PLANNING REPORT

RE: Baldwin Township – BoJack Properties; SSTS Setback Variance

**BALDWIN TOWNSHIP
PLANNING COMMISSION
VARIANCE
FINDINGS OF FACT & RECOMMENDATION**

APPLICATION: Request for variance to allow installation of a Subsurface Sewage Treatment System (SSTS) with setback of less than required by the Town Building Ordinance from an existing well.

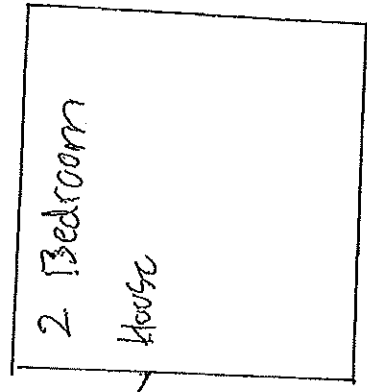
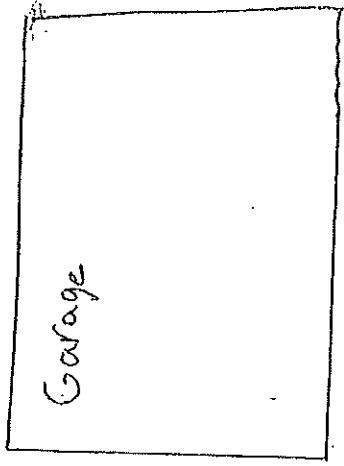
Setbacks. Chapter 4 of the Building Ordinance requires SSTS installations to be setback a minimum of 10 feet from all property lines and buildings within the lot and 50 feet from wells. The site plan included with the SSTS plan indicates that the new system is to be installed at a location that complies with the setbacks required property lines and structures within the lot, but is within the setback from the existing well within the property.

*There is A Shallow well
on the property. New TAPK
And Drain Field is 50' Away
What would you like to do.
(Variance?)*

* Map not to scale
* Well is 50' from drain field

Finding: The proposed location of the SSTS is setback the greatest distance possible from the existing well within the same lot while complying with other applicable setback requirements.

1. Installation of the SSTS shall be installed in accordance with Chapter 4 of the Building Ordinance subject to review and approval of the Building Official except as modified by the variance.
